# TECHNICAL BULLETIN

Heating Systems	November 13, 2007	Bulletin Identification No.: MTB-102-22
Release Type: Public		Standard Repair Time: 45 Minutes

**Affected Model(s):** OASIS CH50

**Description:** Aquastat upgrade

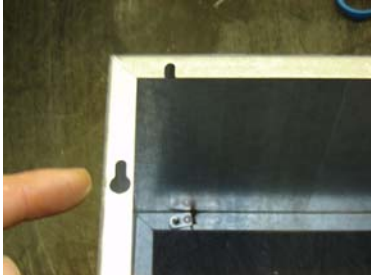
<p>The front section is mounted with a keyhole. Lift up the front section about 1/4" up and the pull forward. The screw head will fit through the keyhole.</p> 
	<p>This is the new cycling aquastat assembly.</p> <p>Part # 2130-20</p>
	<p>To replace the cycling aquastat, remove the top nut and square washer. Loosen the bottom nut. Slide the aquastat out.</p>

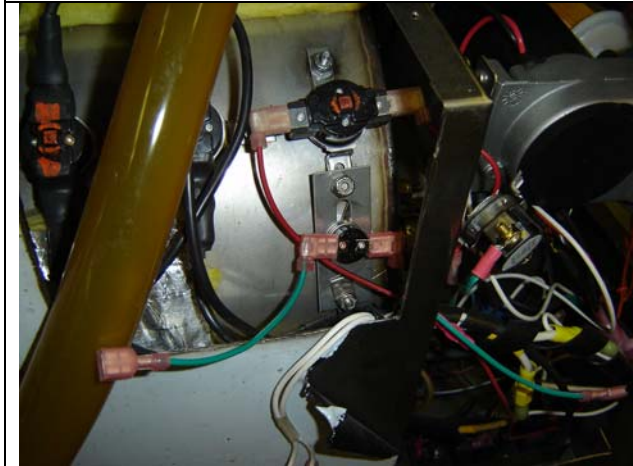
Slide the new aquastat bracket under the bottom square washer in position and tighten the bottom nut.

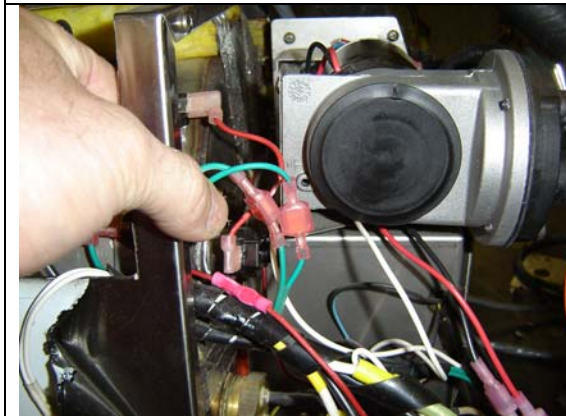
Place a new nut on top and tighten down together with high limit aquastat tab.
